STRUCTURAL – ADDENDUM 1

July 22, 2026 **Project Number:** 21032

Project Name: The Sterling Hall School

The following are changes to the tender documents and are effective immediately. This addendum forms part of the contract documents issued previously. All changes are clouded in drawings.

GROUND FLOOR FRAMING PLAN

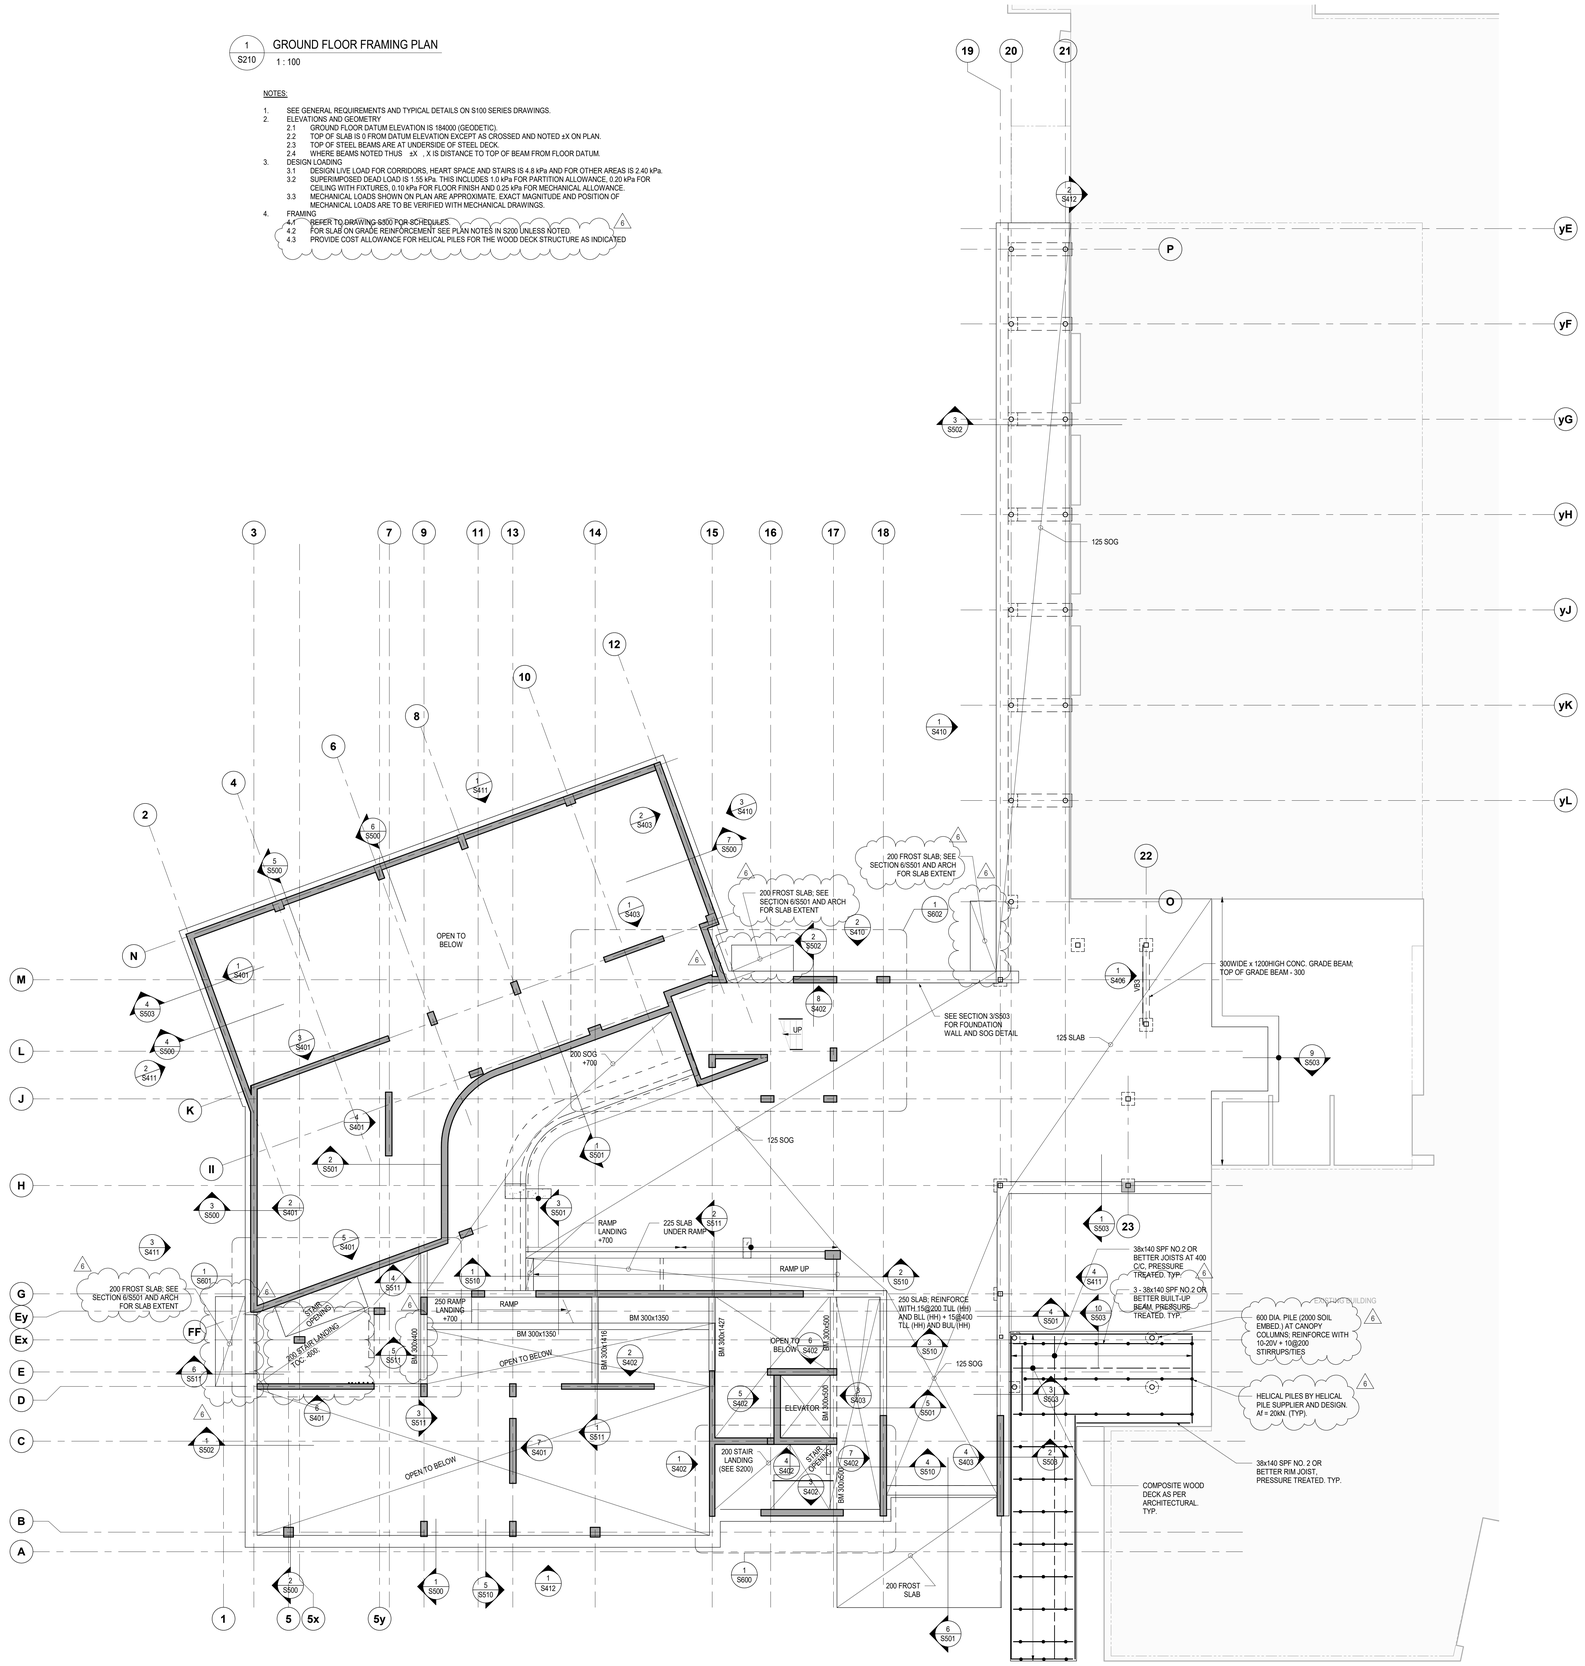
2.3.1 Added notes as clouded

2.3.2 Added frost slabs at entrances

2.3.3 Revised wood deck framing

MEZZANINE LEVEL FRAMING PLAN

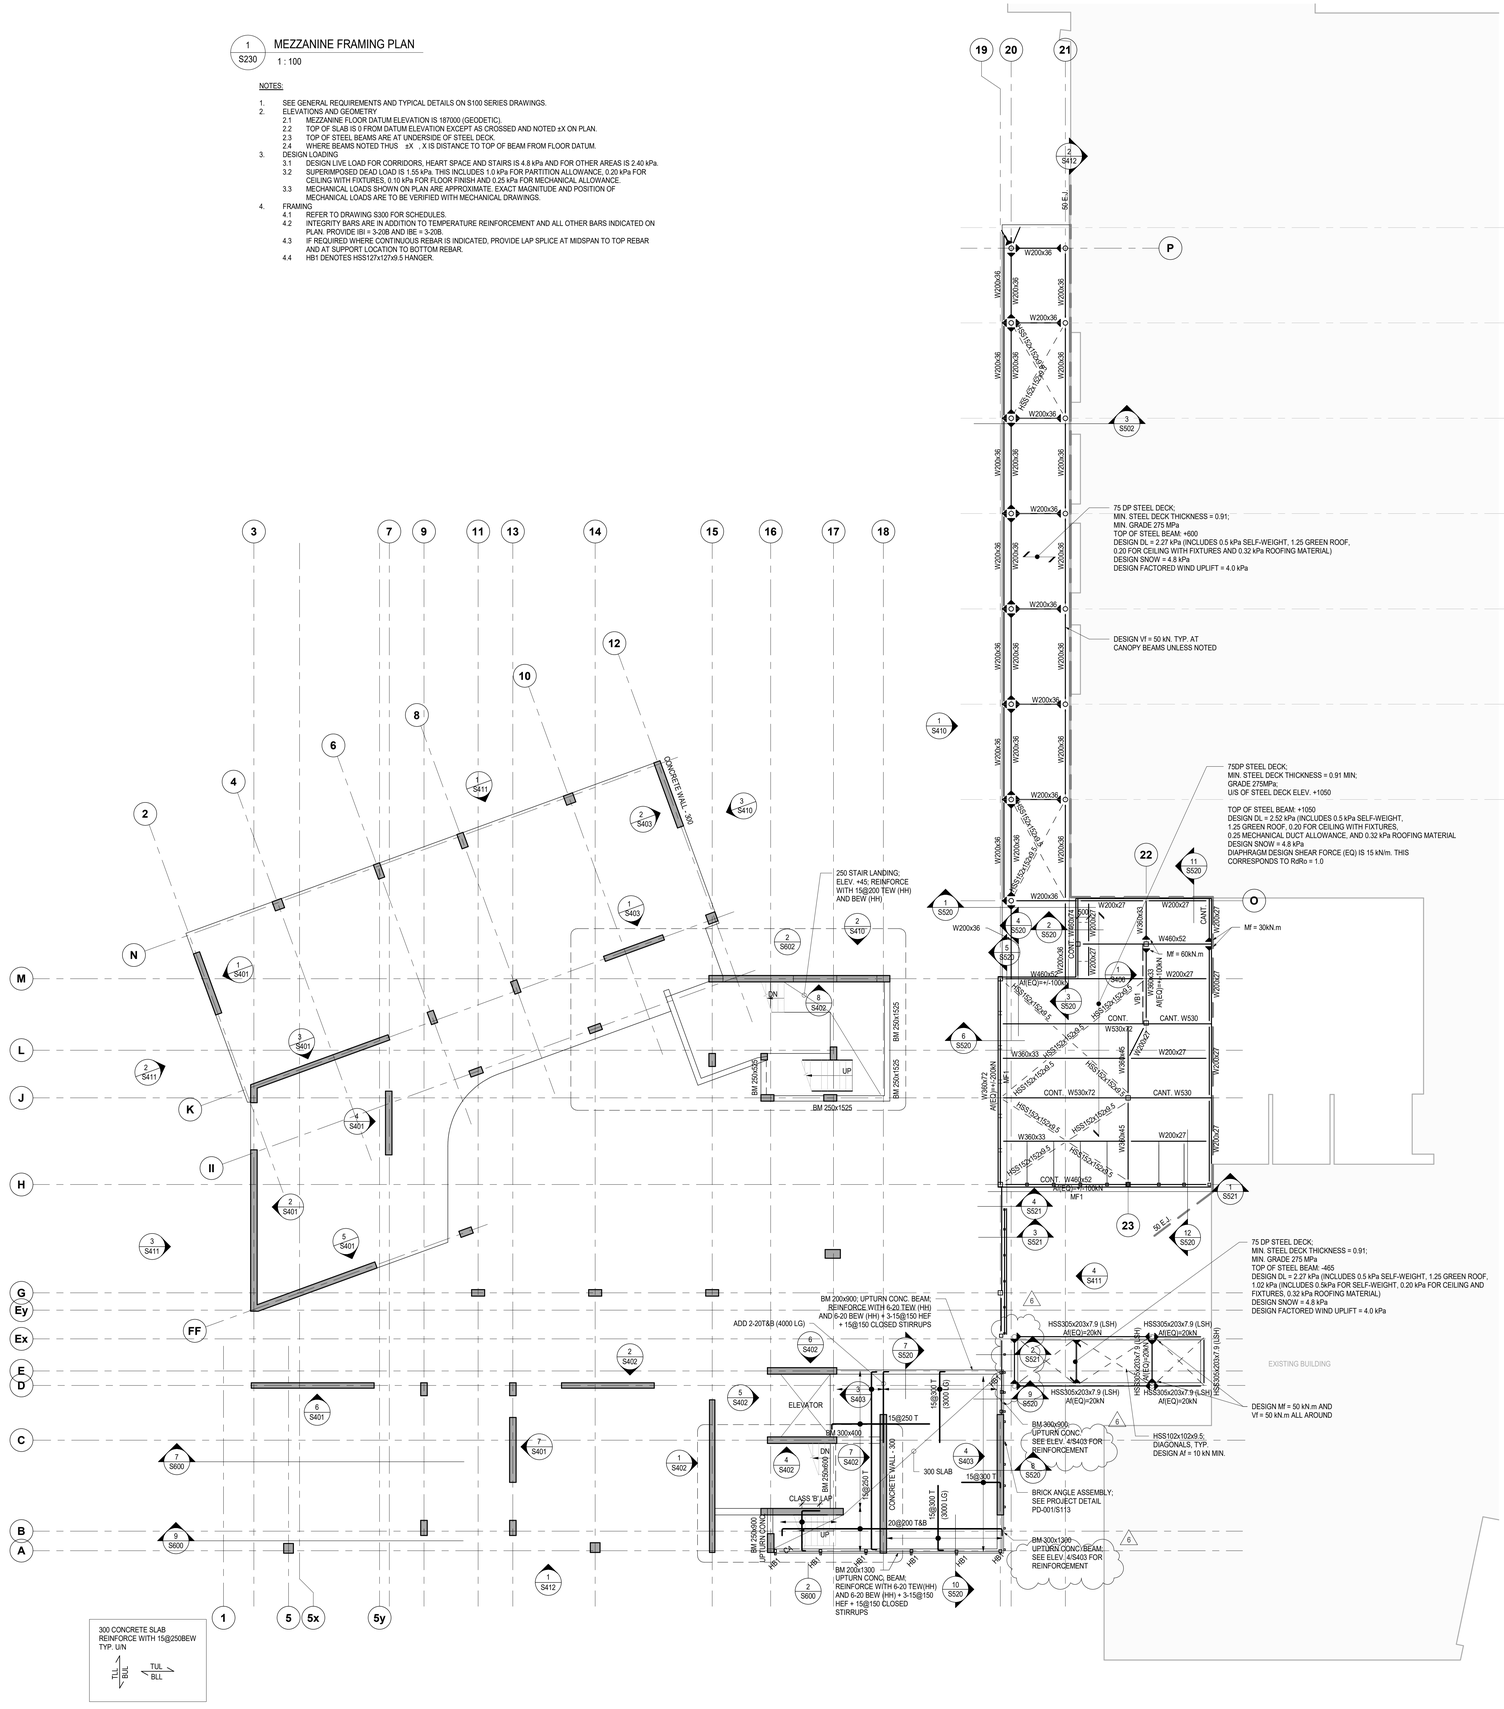
2.4.1 Revised concrete beam and reinforcement.

2.4.2 Revised structural steel framing

SECOND FLOOR FRAMING PLAN

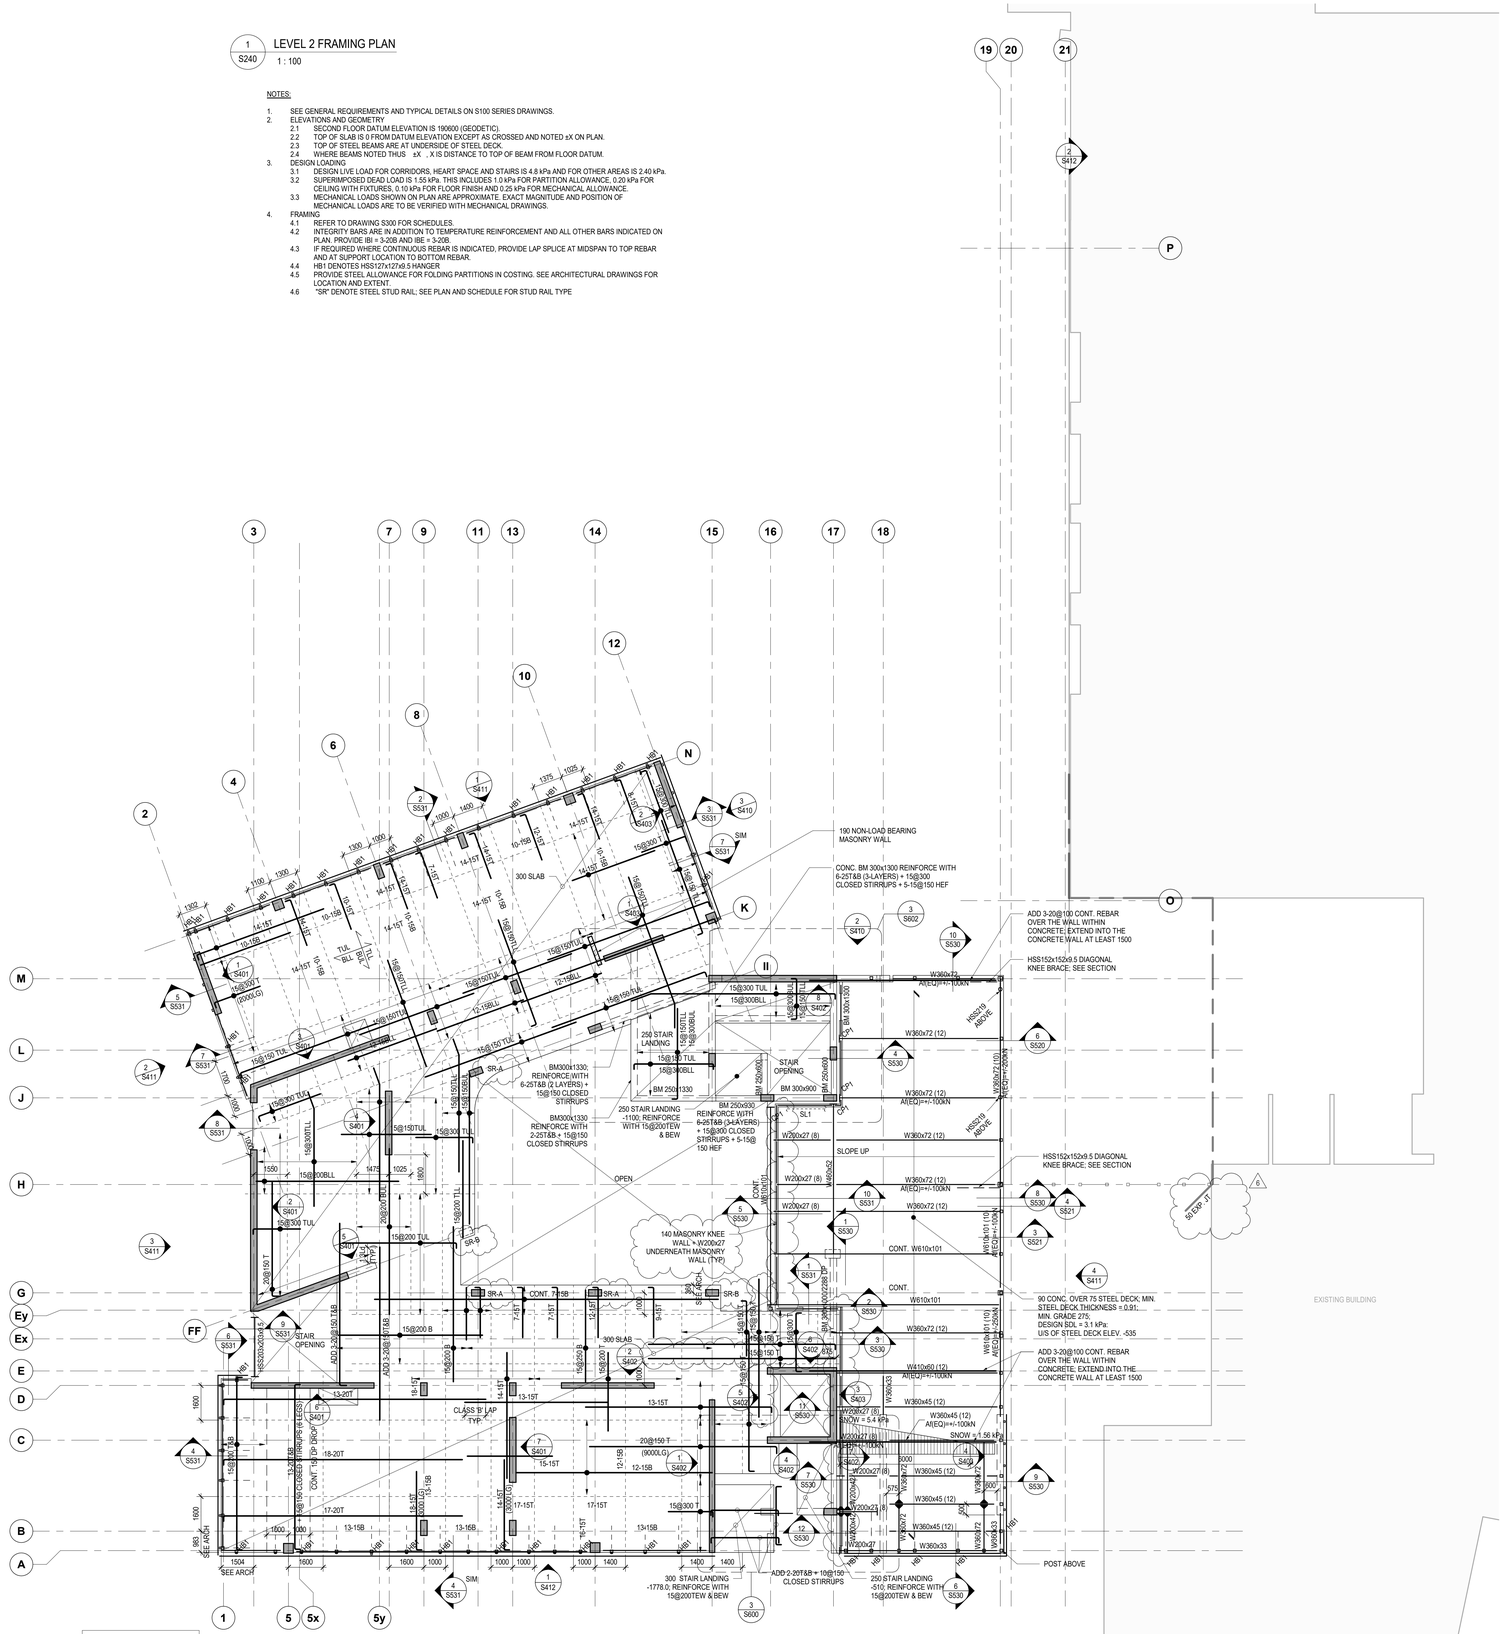
2.5.1 Added shear stud rails at columns

2.5.2 Added masonry knee wall for brick veneer support

2.5.3 Revised structural steel framing

LOW ROOF FRAMING PLAN

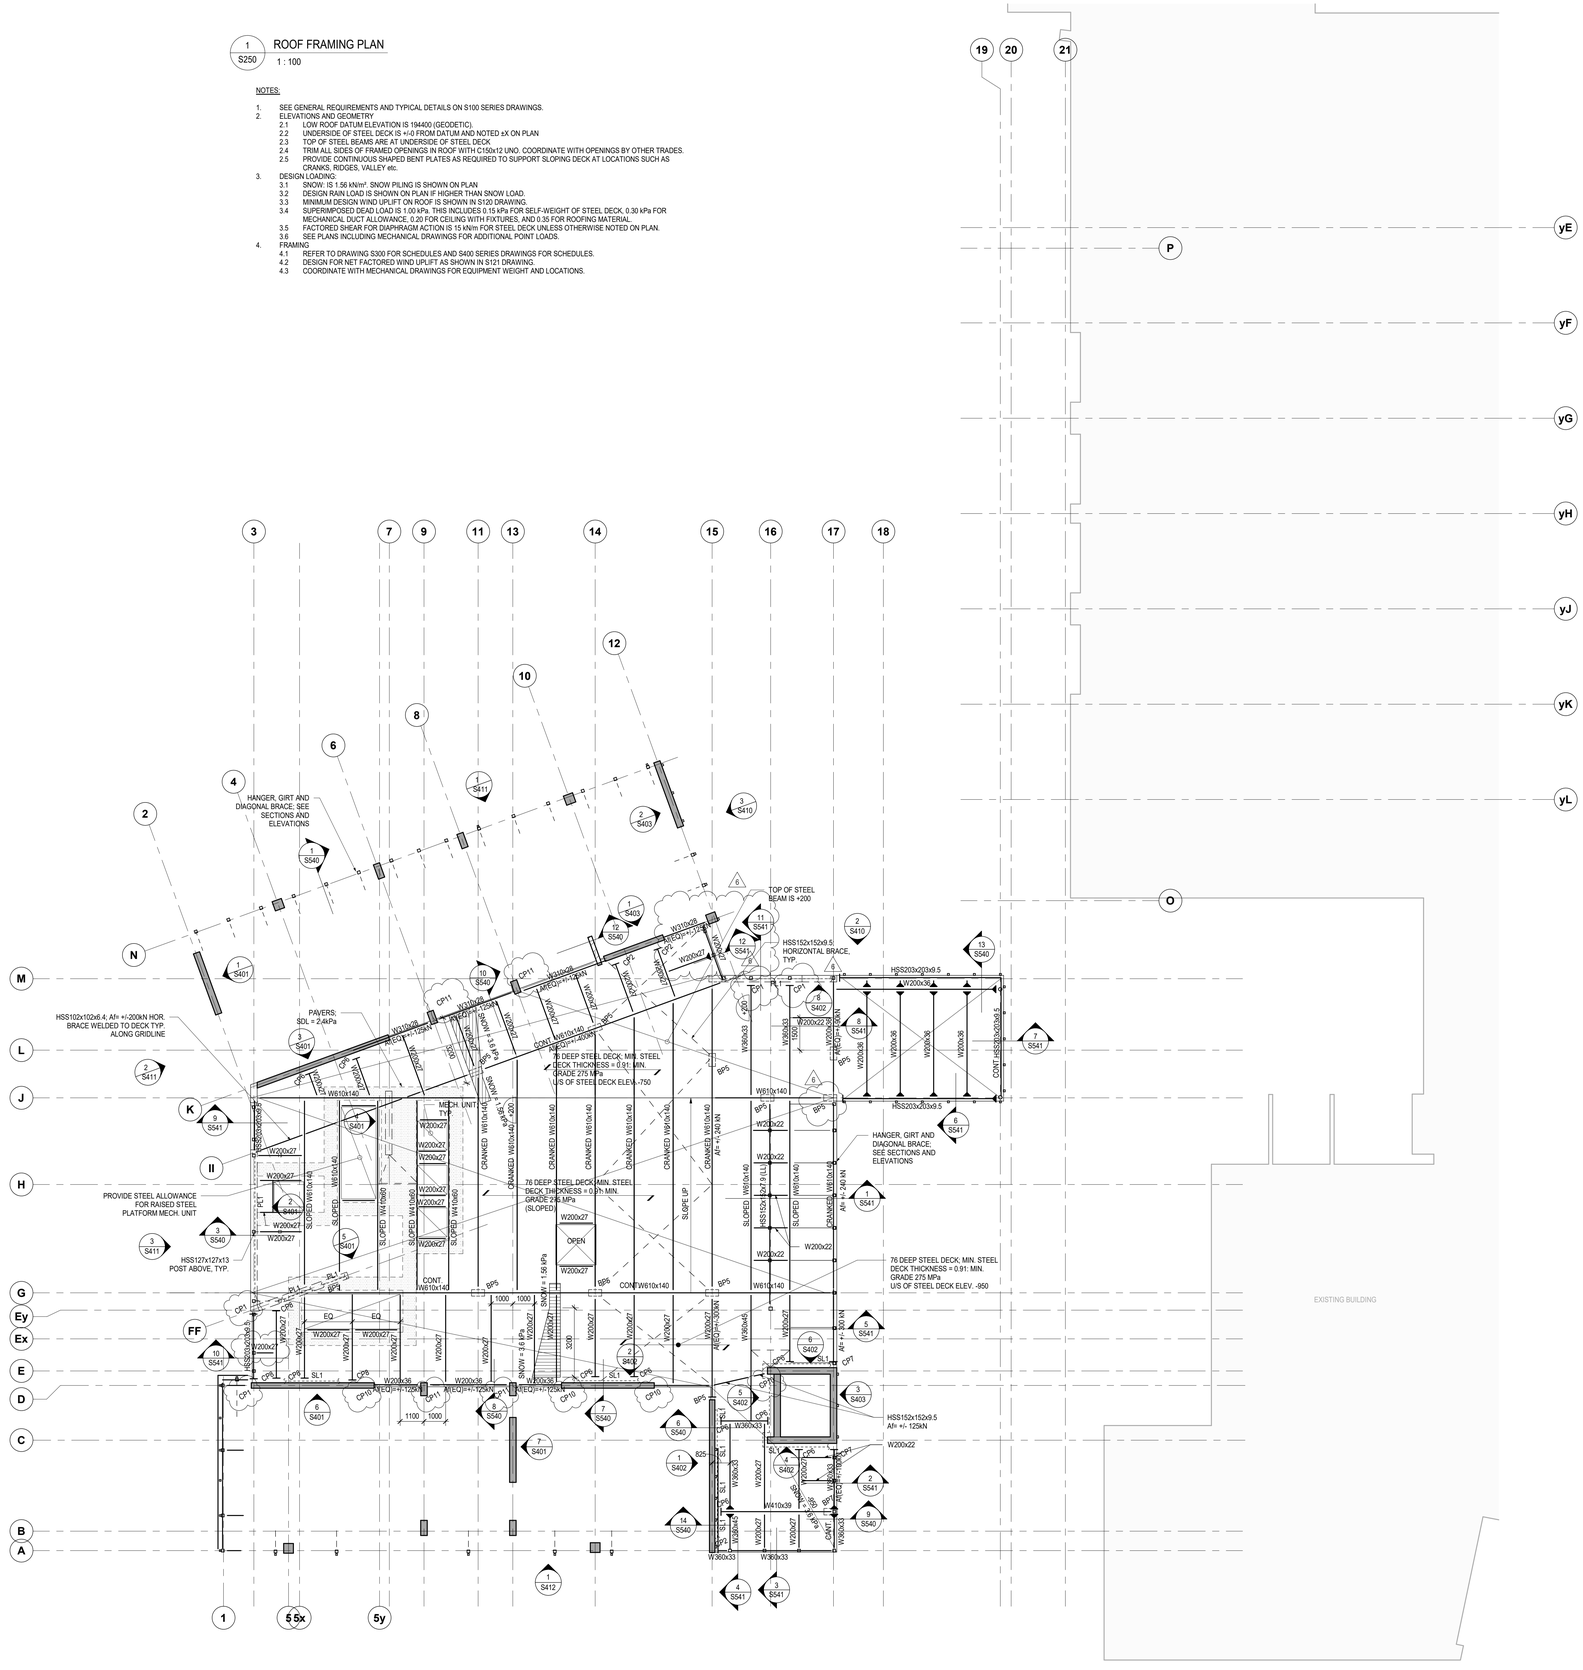
2.6.1 Revised structural steel framing

2.6.2 Added connection plate and bearing plate

1 S400 GROUND FLOOR SHEAR WALL KEY PLAN
1 : 100

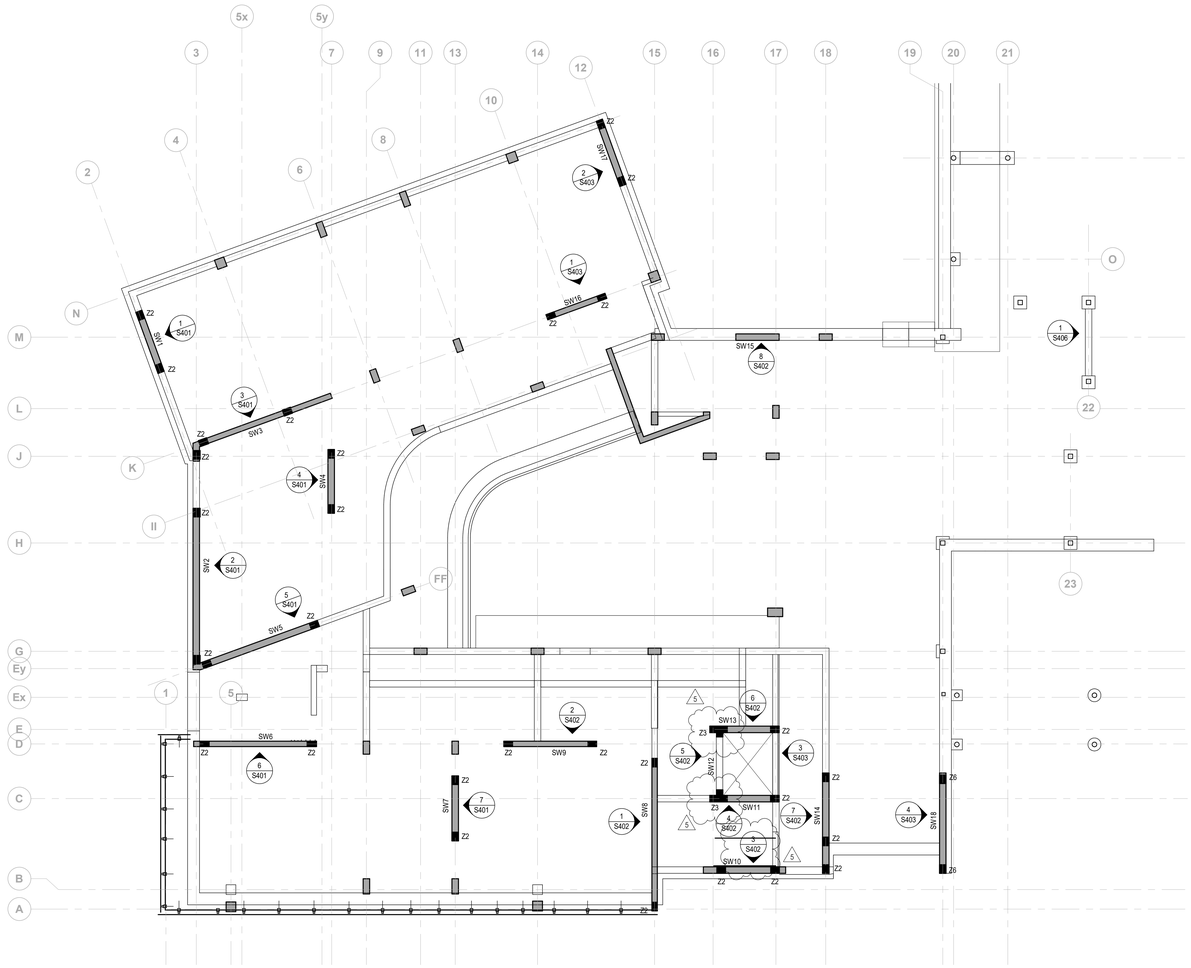
2.7.3 Revised concrete shear wall typical detail
